SPECIAL BOARD MEETING

APRIL 11, 2018

- 5.1 Approval of Change Order for Center Glass for added items to the STEAM project.
- 5.2 Approval of Change Orders for Taft Electric as outlined below.
- 5.3 2018 Local District Facilities Update and GO Bond, and potential District General Obligation Bond for November 2018.
- 5.4 Review the Results of the GO bond survey and Accept the facility program needs of the District.

TITLE: BLDG E ELECTRICAL ROOF PLAN

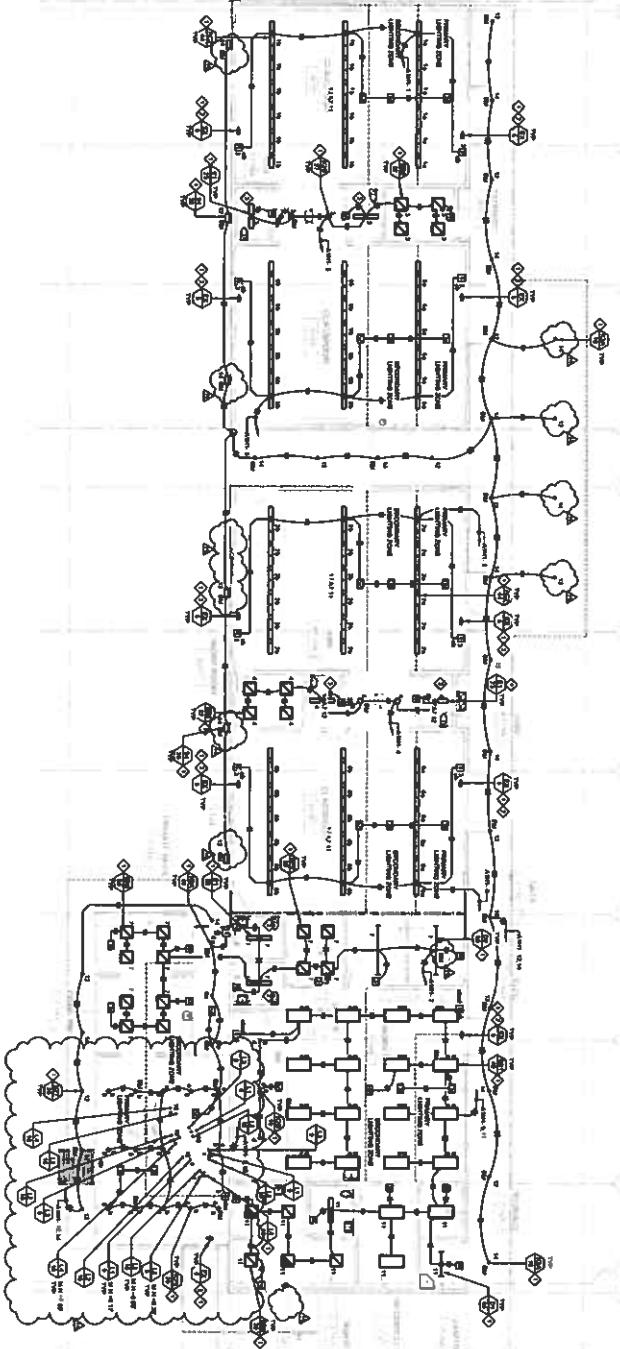
SHT E 3.51-Bldg E Electrical Roof Plan

EL2.11

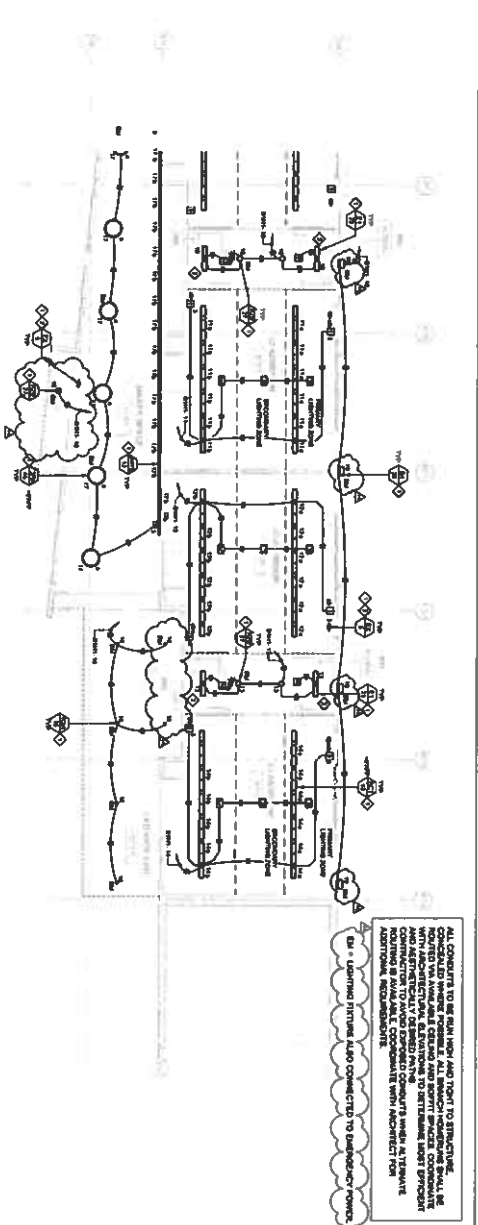
SHT EL 2.11-Bldg A First Floor Lighting Plan

1. Added egress fixtures and adjusted location of egress lighting fixtures.
2. Updated lighting fixture identification at Visitor Waiting reception desk.
3. Included canopy and lighting fixtures located between Bldgs. A & E

BLDG B FIRST FLOOR LIGHTING PLAN

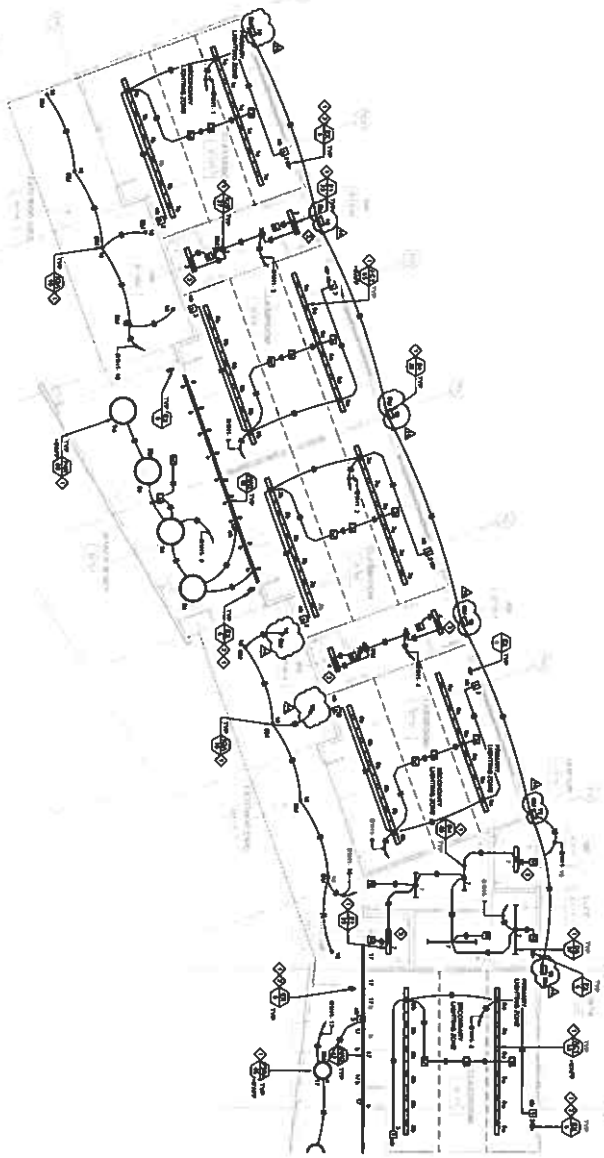
SHT EL 2.11-Bldg B First Floor Lighting Plan

1. Added egress fixtures and adjusted location of egress lighting fixtures.

THE
BLDG B ELECTRICAL
ROOF PLAN
E3.21

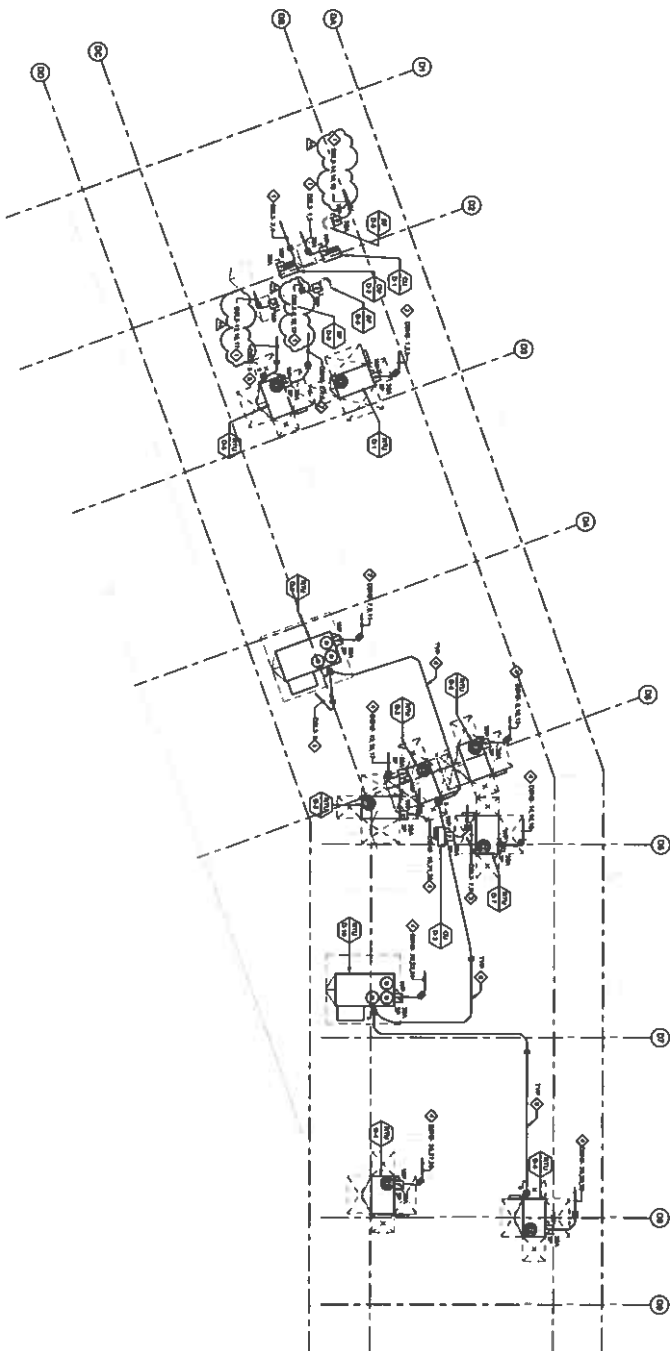
SHT E 3.21-Bldg B Electrical Roof Plan

**BLDG D ELECTRICAL
 ROOF PLAN**

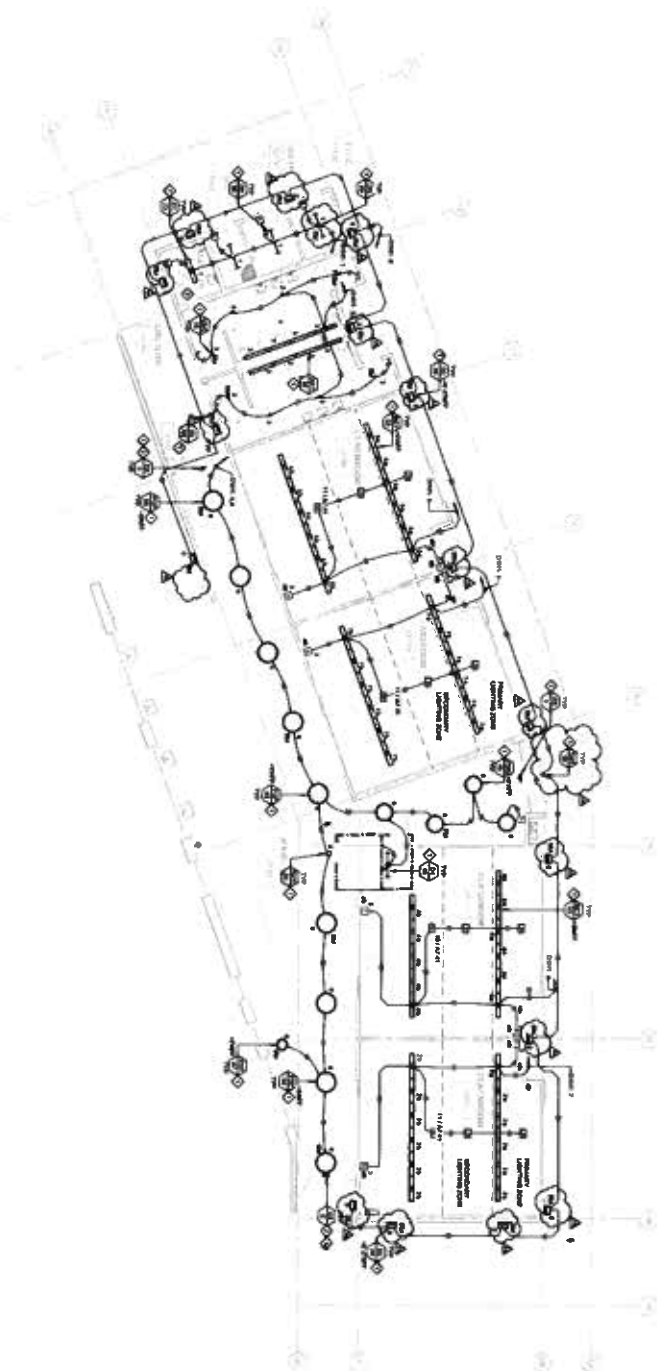
SHT E 3.41-Bldg D Electrical Roof Plan

EL2.41

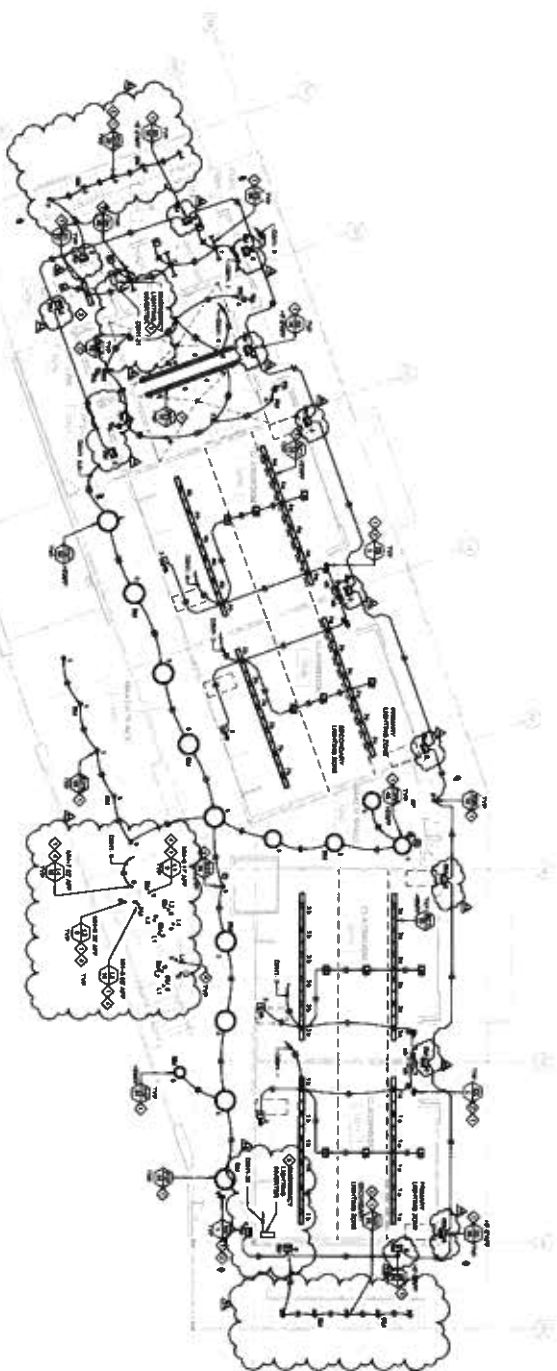
SHT EL 2.41-Bldg D First Floor Lighting Plan

1. Added egress fixtures and adjusted location of egress lighting fixtures.

EL2.42

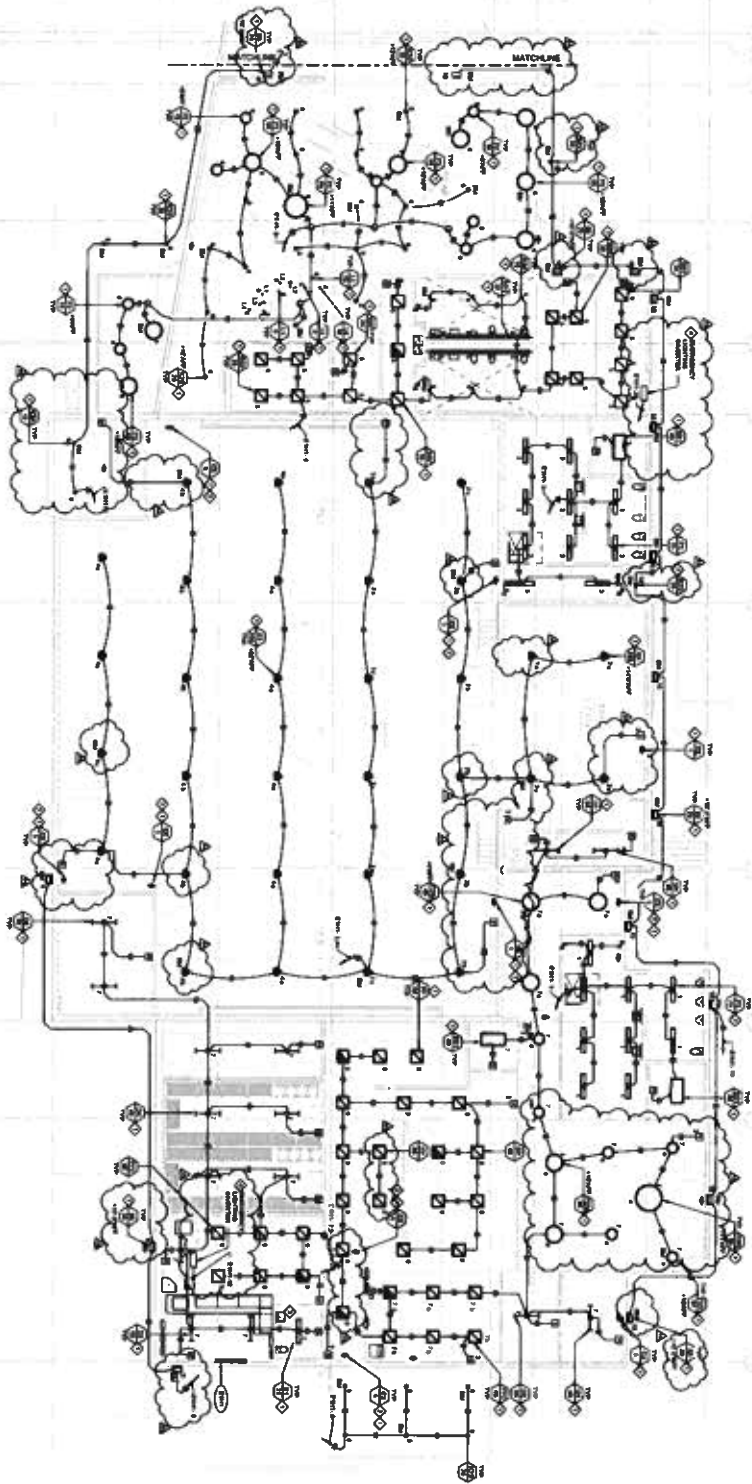
SHT EL 2.42-Bldg D Second Floor Lighting Plan

1. Added egress fixtures and adjusted location of egress lighting fixtures.
2. Added egress fixtures over stairs at east and west sides of building.

BLDG E FIRST FLOOR LIGHTING PLAN
EL2.51

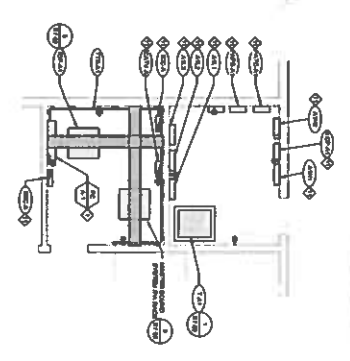
SHT EL 2.51-Bldg E First Floor Lighting Plan

1. Added egress fixtures and adjusted location of egress lighting fixtures at perimeter of building and corrected light fixture designations at the Stage and Gym areas.
2. Added (2) 2x2 fixtures in the Kitchen area.
3. Adjusted lighting layout above the POS registers in the Serving area.
4. Included canopy between Bldgs. A & E and added (4) linear fixtures / emergency battery packs.

PROJECT: EP2.11

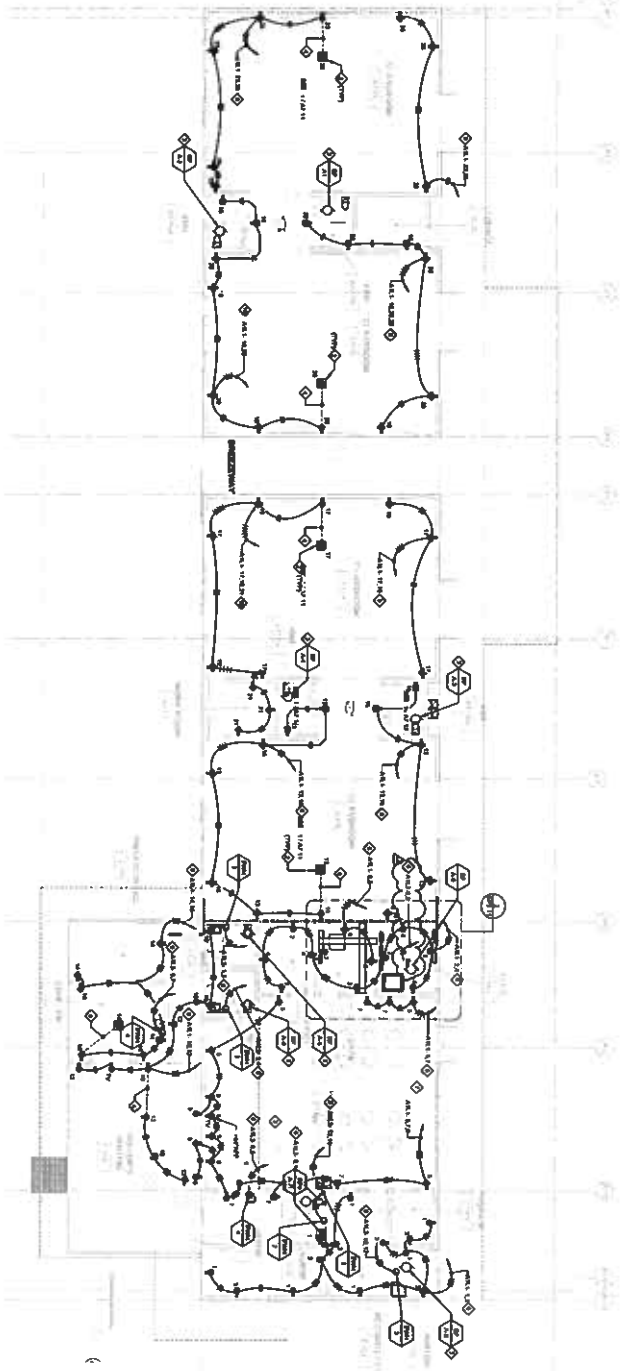
SHT EP 2.11-Bldg A First Floor Power Plan

1. Corrected Exhaust fan circuiting at Bldg. A Electrical Room.

THIS
BLDG D FIRST FLOOR
POWER PLAN

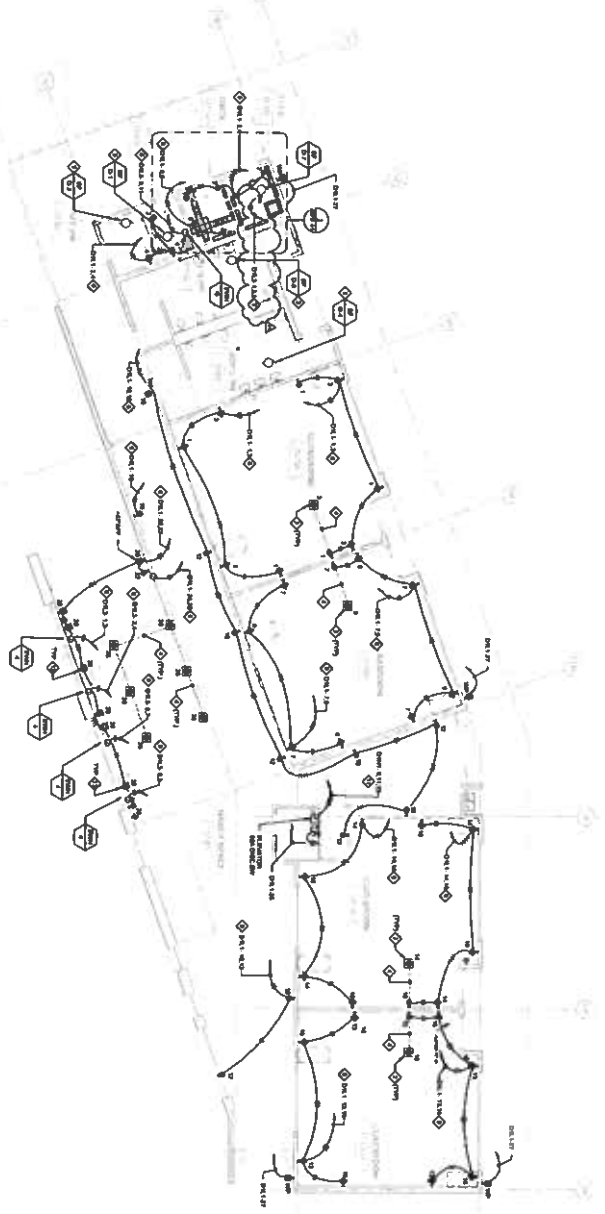
SHT EP 2.41-Bldg D First Floor Power Plan

PER RFI#0296

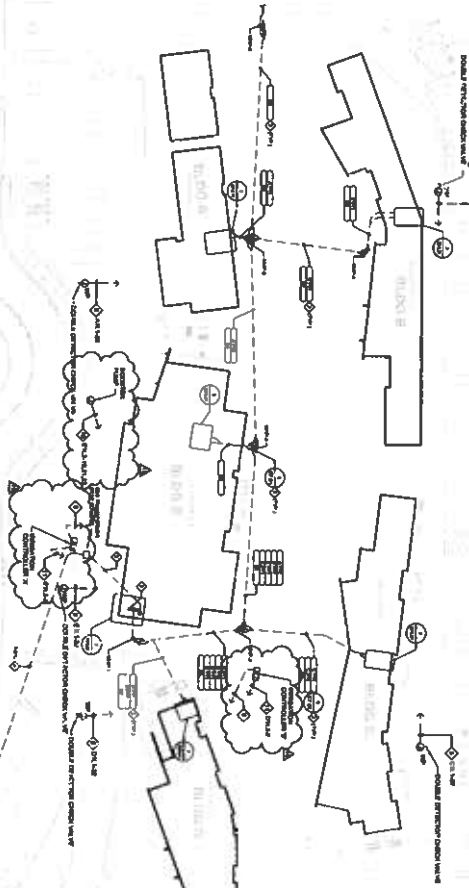
The Landscape contractor has brought to our attention that there is a 230V 3phase pump on the site. The pump is not shown or referenced in any of the electrical plan sheets including the panel schedules. Please confirm power requirements for the approved pump, panel that should feed the pump, breaker size, conduit and wire size. Once information has been received a PCO/COR proposal will be prepared for approval.

SEE ATTACHED REVISED SHEET E1.03 AND REVISED PANEL SCHEDULES D1L2 AND E1L2.
